# FAIRFAX COUNTY

## STAFF REPORT

RZ/FDP 2000-MV-051

OVERALL CONCEPTUAL/  
FINAL DEVELOPMENT PLAN  
**SKYVIEW PARK**  
LIE DISTRICT  
FAIRFAX COUNTY, VIRGINIA

TYPICAL LANDSCAPING  
FOR LIGHT FIXTURES  
SEE TO SCALE

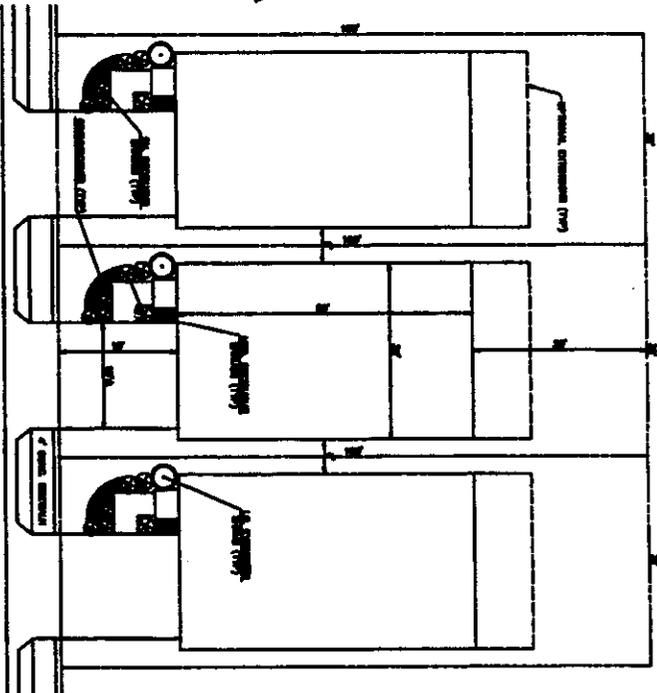
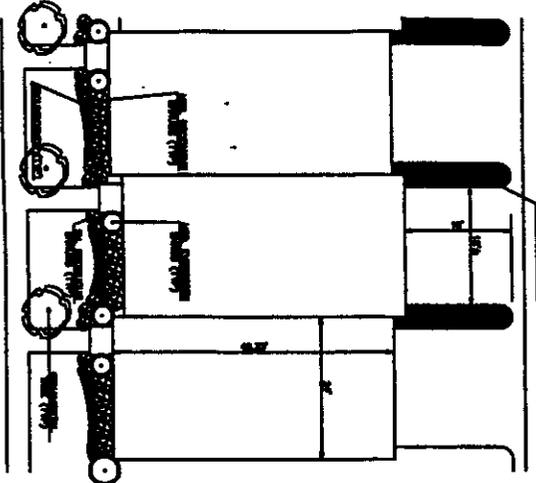
- 5. Comment:** The "Typical Landscaping" details provided on sheet 5 of 7 are not drawn to scale. Minimum areas are required for all planted trees, and without a to-scale drawing, the areas provided for these trees cannot be evaluated. If these trees cannot be planted in the areas as shown, this CDP/FDP will not realistically convey what is proposed to be planted for the individual units.

TYPICAL STREETSCAPE  
FOR RICHMOND HIGHWAY  
SEE TO SCALE

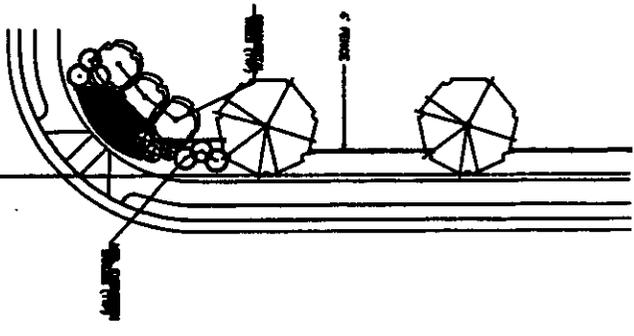
Details of the proposed streetscape along the perimeter of the site and along the site's Richmond Highway frontage are provided on Sheet 8 of the CDP/FDP. The proposed Richmond Highway streetscape is depicted to consist of an eight (8) foot wide landscape strip, a ten (10) foot wide multipurpose trail, and a seven (7) foot wide planting strip. Sheet 4 of the CDP/FDP indicates that a masonry wall four (4) feet in height would be located between the proposed units and the seven (7) foot wide planting strip. A note on the CDP/FDP indicates that twenty (20) feet from the ends of this wall, the height would gradually increase up to six (6) feet in order to transition into the six (6) foot high masonry wall proposed to be located in the side yards. The applicant is seeking a variance of the height of the wall in these sections. A detail of the proposed brick wall is depicted on Sheet 7.

Details of the proposed streetscape along Manor Drive, Frye Road and Sky View Drive, are also depicted on Sheet 8. Despite the note on Sheet 8 which states "for illustrative purposes only," the applicant has proffered to provide the depicted streetscape for all street frontages.

The proposed streetscape along Richmond Highway is consistent with the Comprehensive Plan streetscape guidelines for Richmond Highway. In addition, the applicant has proffered to provide an integrated streetscape for the site's frontage along Manor Drive, Frye Road and Sky View Drive, as depicted on Sheet 8 of the CDP/FDP. Therefore, this issue is now resolved.

A) Irrespective of the note on the CDP/FDP, the Applicant will develop an integrated streetscape plan for the frontage of the property along Richmond Highway, Skyview Ave., Manor Dr. and Frye Rd as shown on the CDP/FDP exhibit in detail on sheet 8 of 11. Applicant will construct the streetscape in front of parcels 101-3 ((10)) lots 6,7,10 101-3 ((1)) Parcel 43 within the ROW, but only if the owners grant all on site easements if necessary for construction of the frontage improvements. The obligation specified in this proffer to install the off-site streetscape and frontage improvements on parcels 101-3 ((10)) 6,7,10 and 101-3 ((1)) 43 is

SINGLE-FAMILY DETACHED UNIT

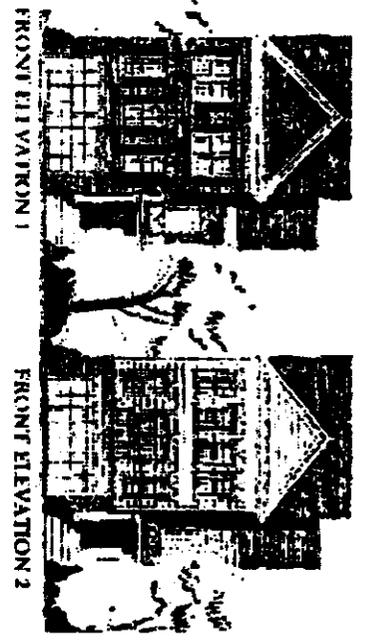
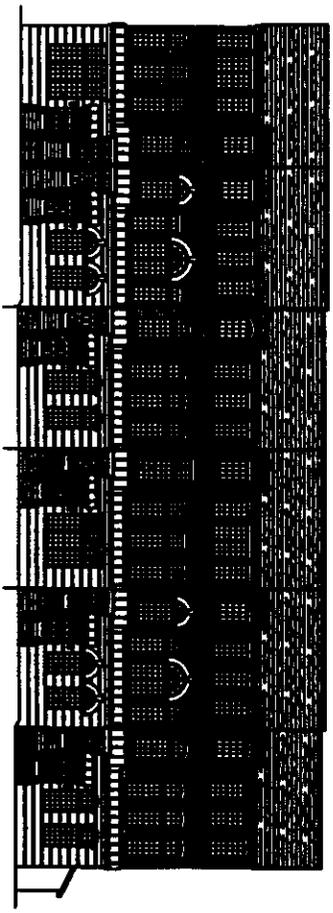
Proposed elevations are depicted on Sheet 7. These architectural elevations include two designs for the proposed single-family detached units, a design for the rear-loaded garage townhouses, a design for the rear-loaded garage condominiums, and a design for the front-loaded garage townhouses.
